NOTICE PLAN COMMISSION March 17, 2015

TO: Plan Commission
FROM: Tom Hovel, Zoning Administrator/City Planner
Susan Badtke, Community Planner
DATE: March 12, 2015
SUBJECT: March 17, 2015 Plan Commission Items

**Amendment to
Comprehensive Development Plan
Previously Approved
Under Resolution R-12-14
Quarry Vista
Fitchburg, Wisconsin**

FIGURE
3

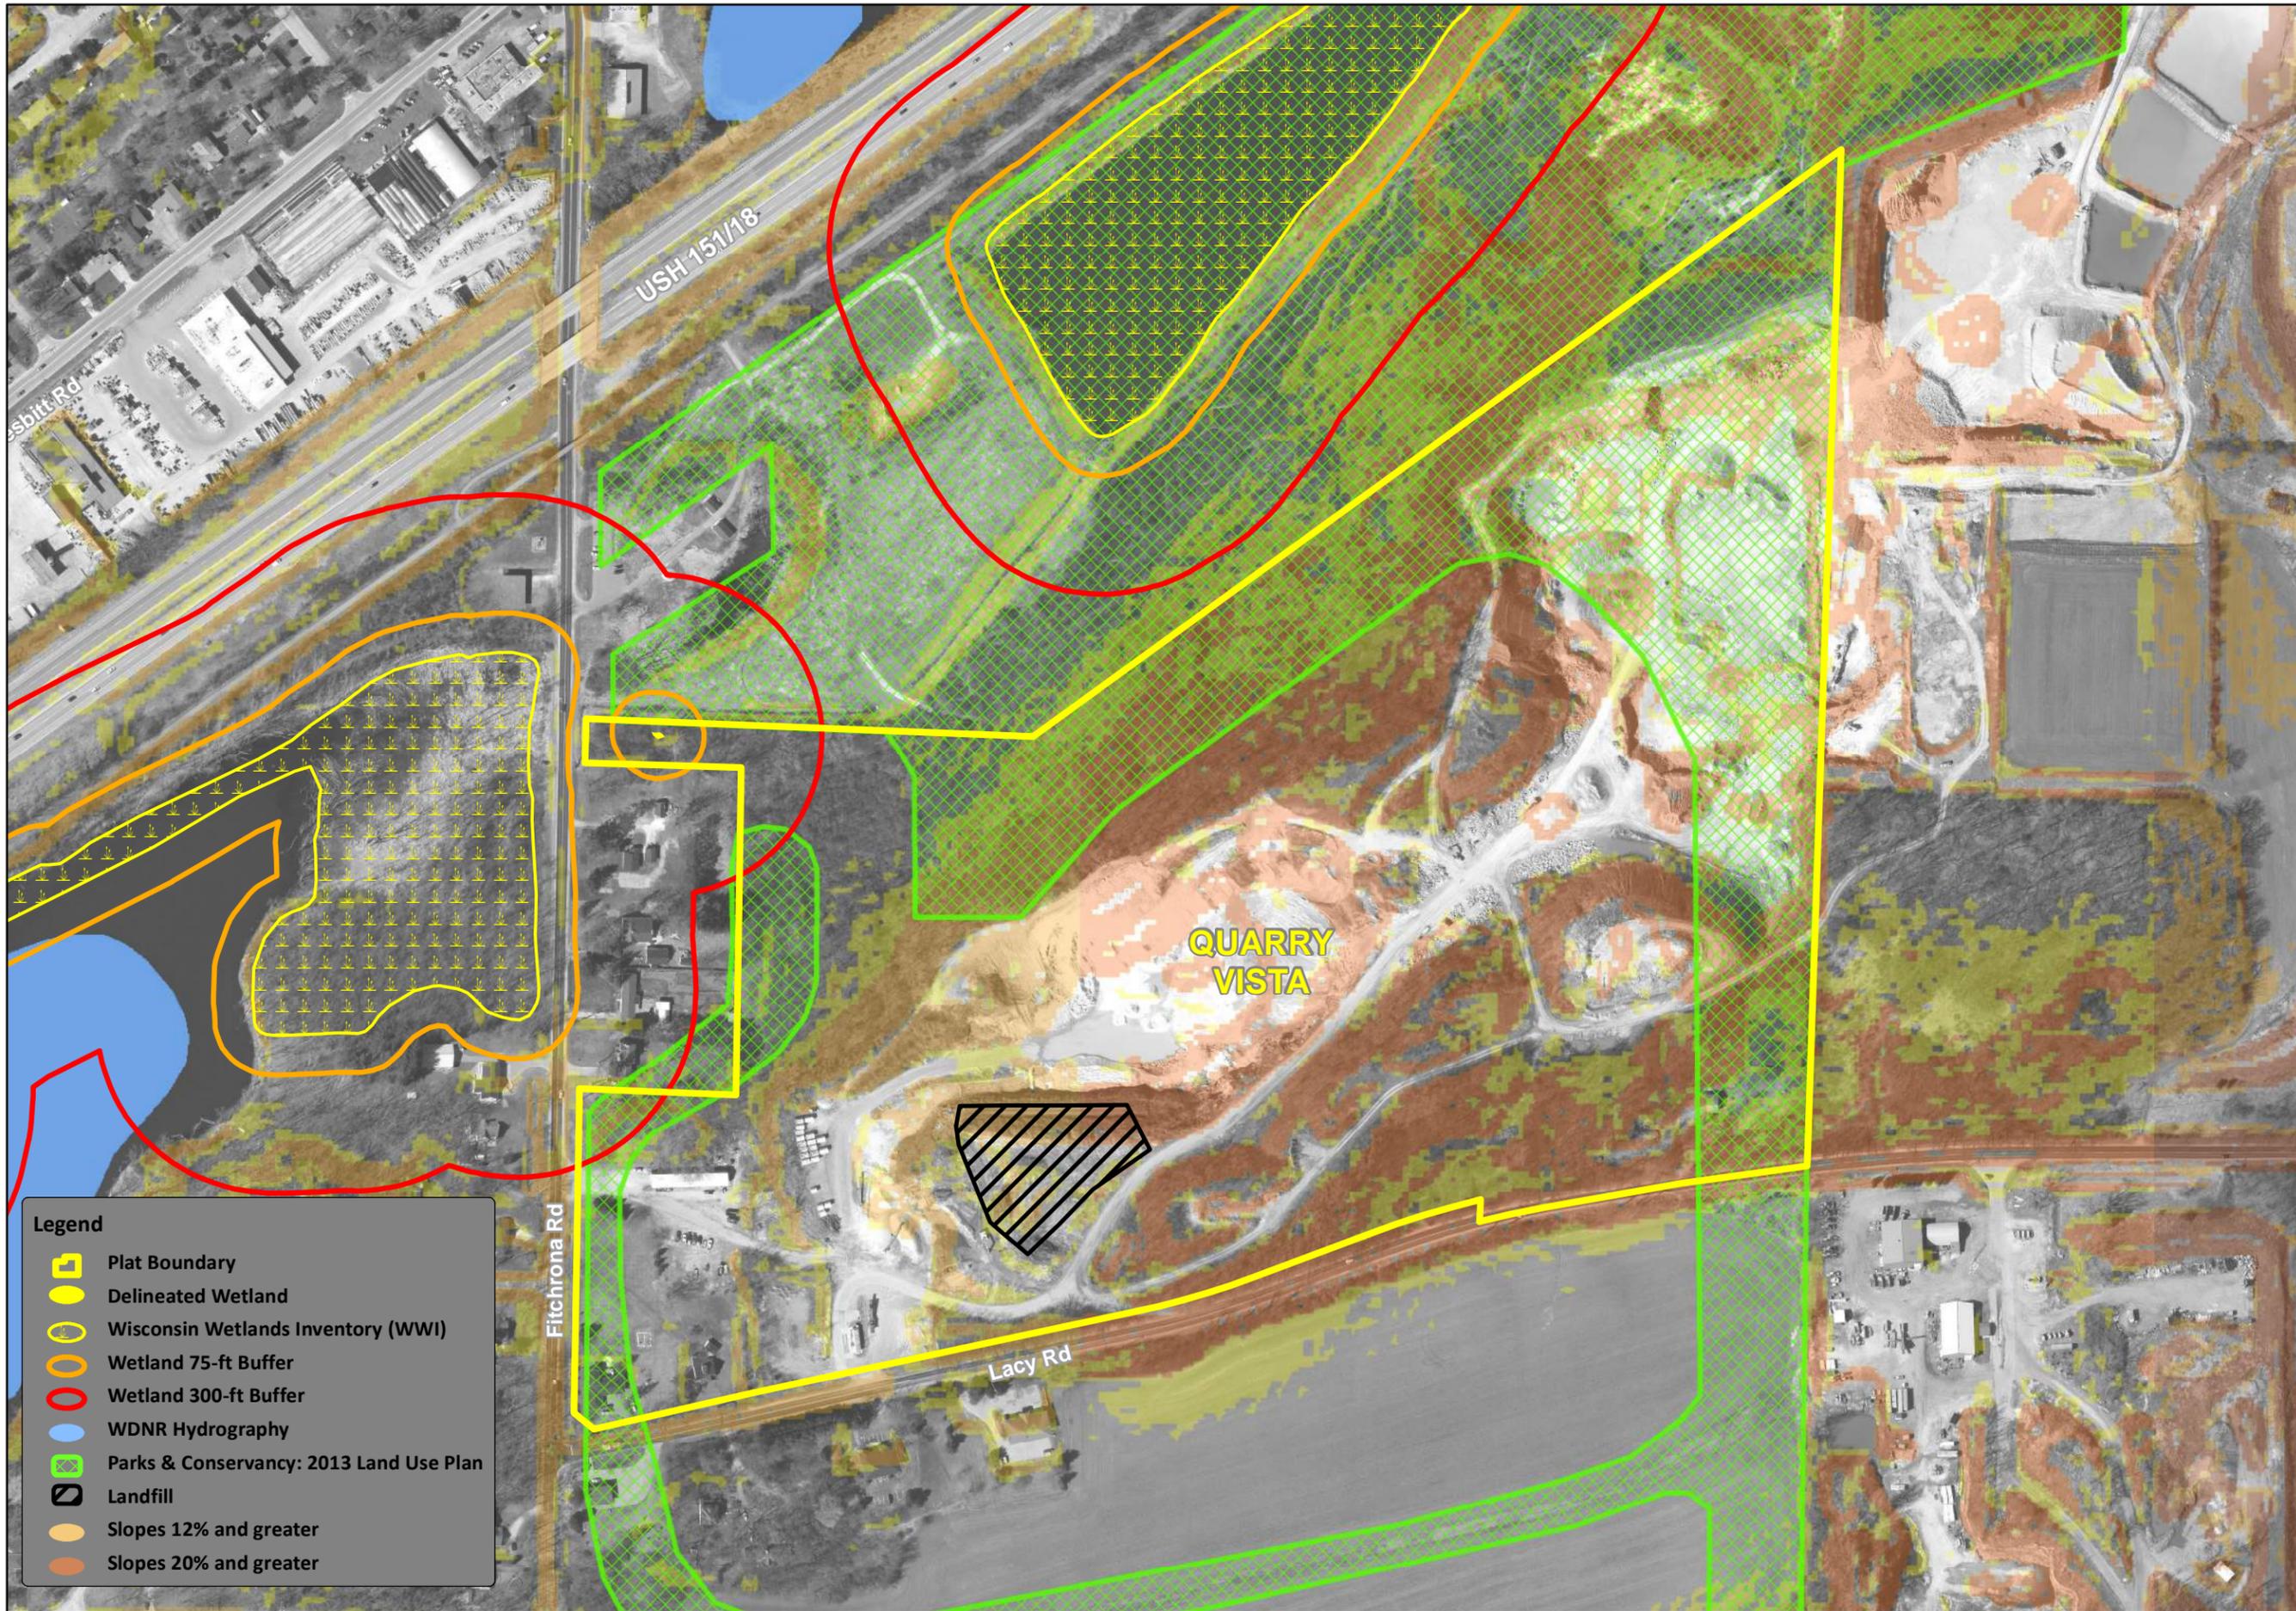
2. CDP – Figure 3 – Please confirm if DNR has determined the Quarry Ridge Greenway to be “navigable”. If so, please update Figure 3 to show appropriate offsets.

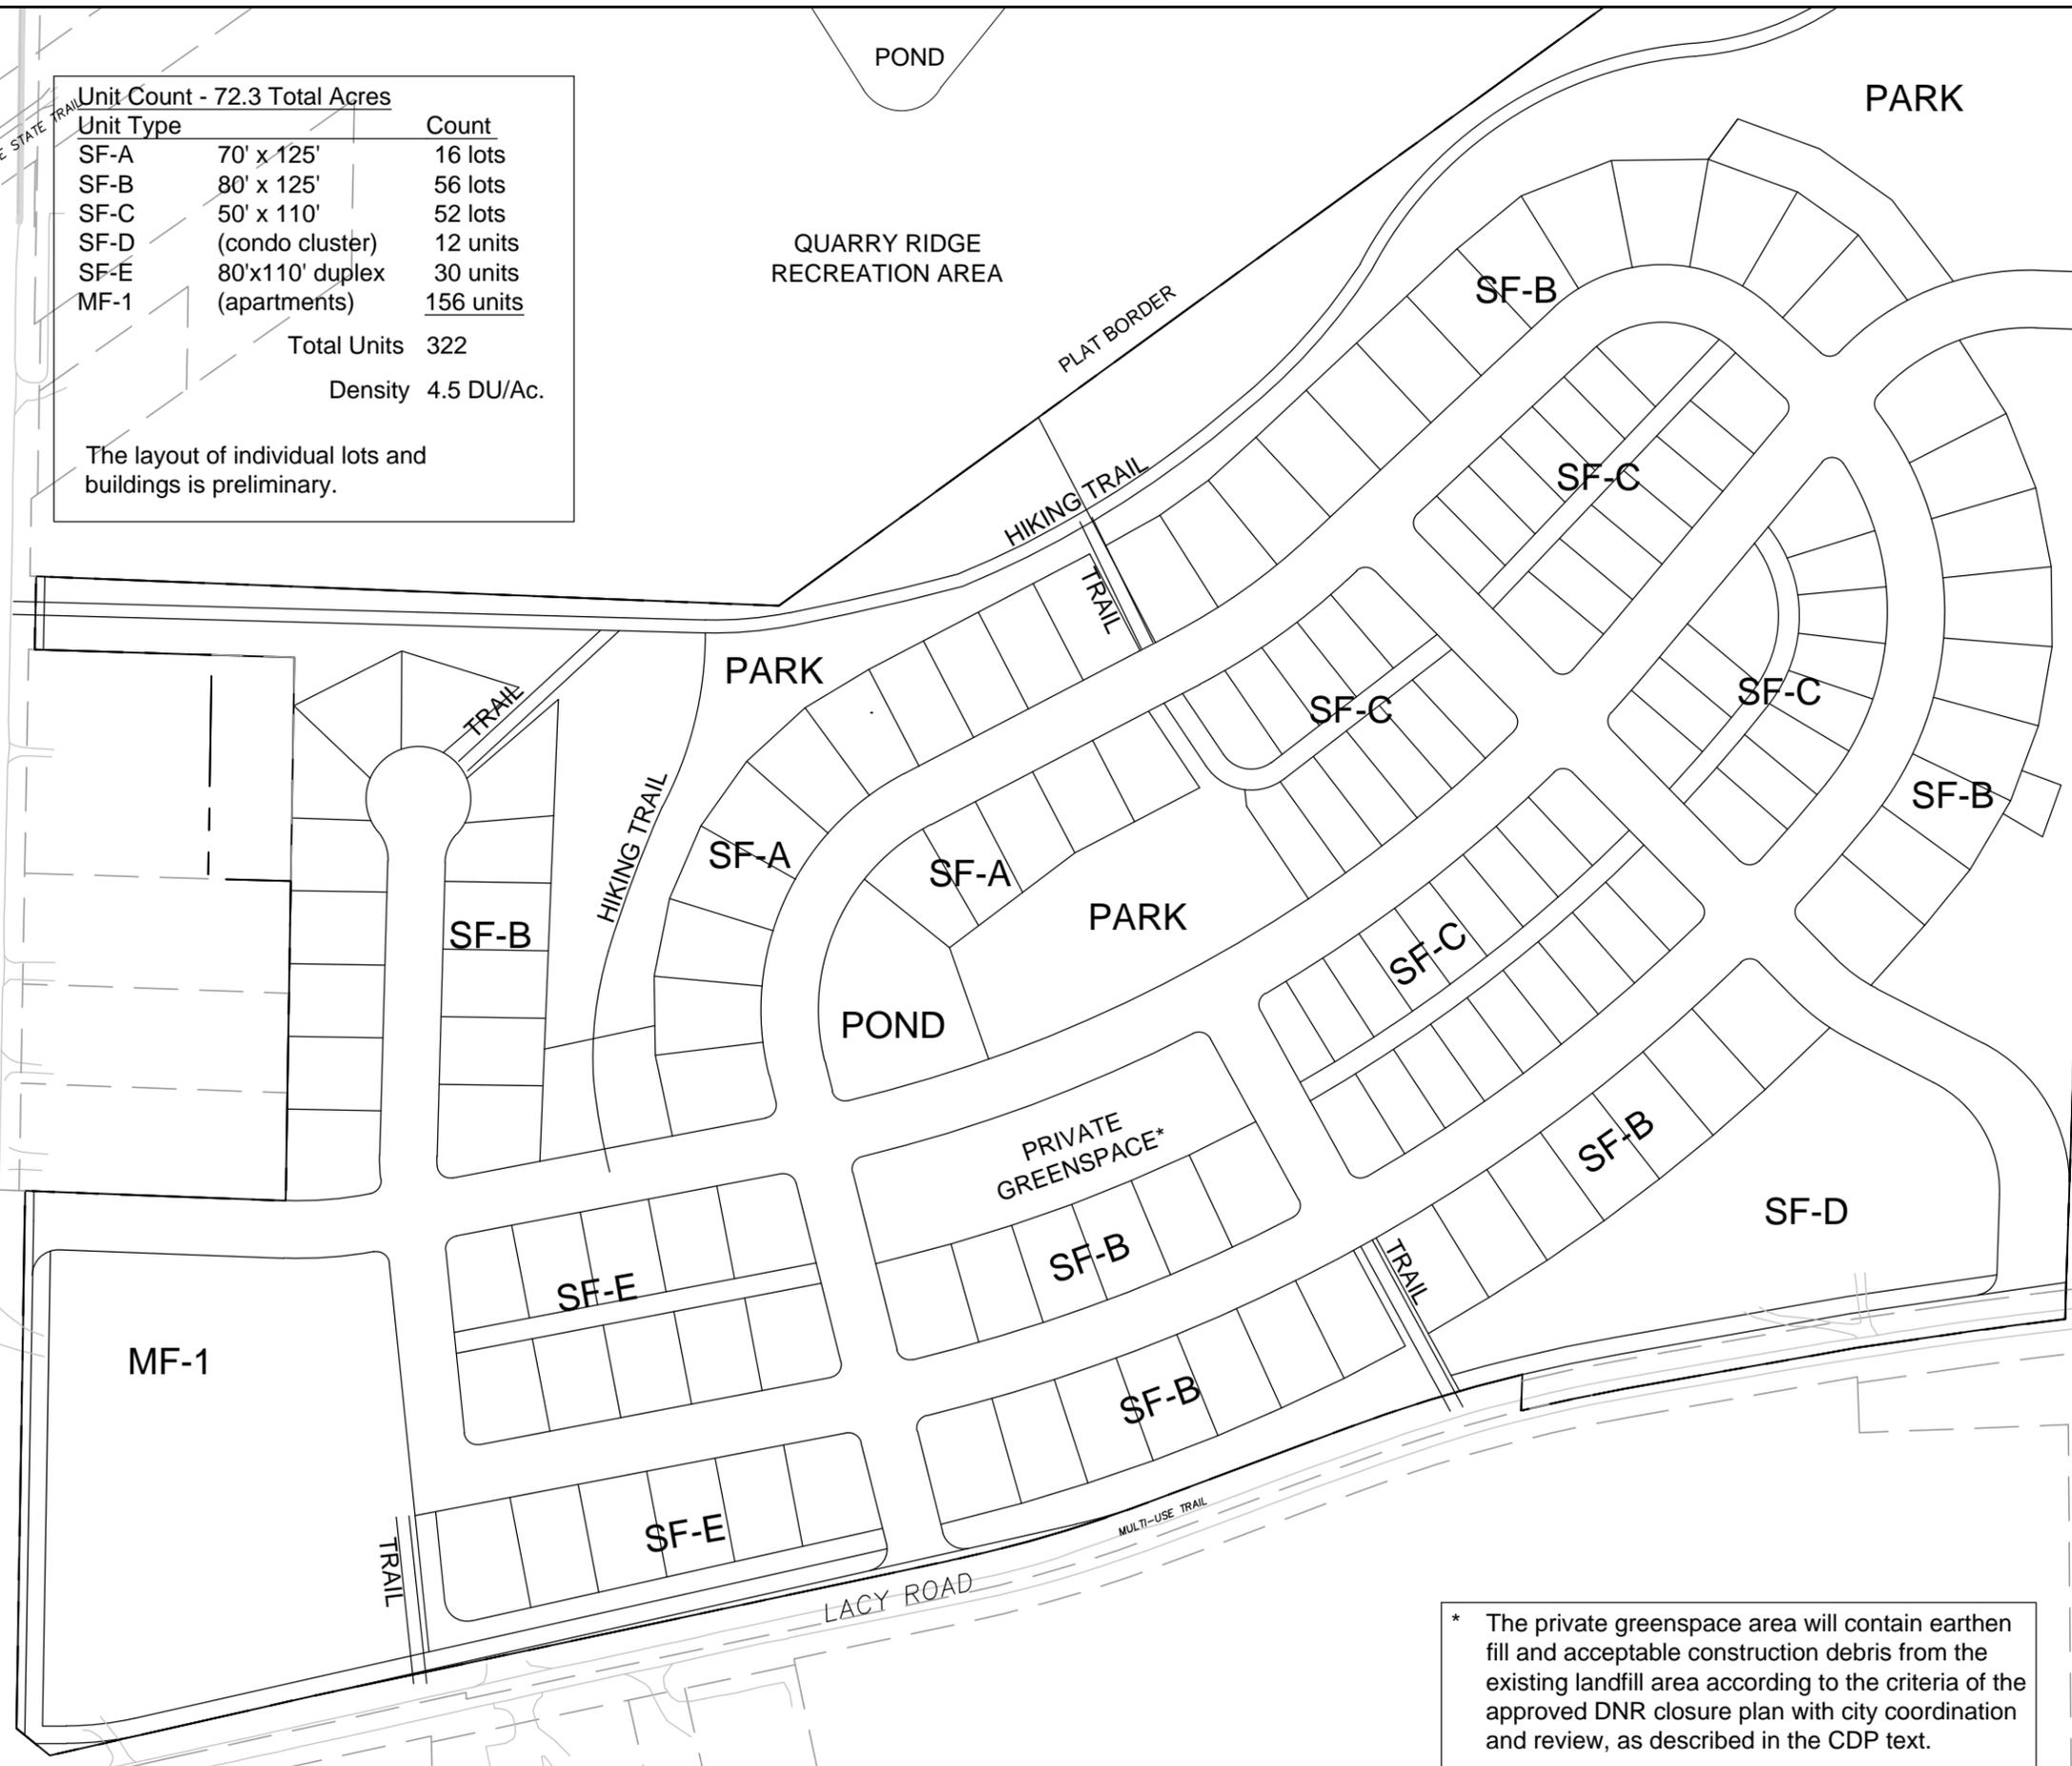
Response: The section has been revised to reflect the rezoning which has already taken place.
- 5.) Page 6, Proposed Housing Mix - references an Exhibit but does not identify the number. Should this be Exhibit 4?

Response: The reference has been revised to say "Figure 4".
- 6.) Page 6 Section 3.1 – the total units and mf count will be reduced than that shown (indicate 156 mf units but approved GIP for proposed lot 46 is 152 mf units).
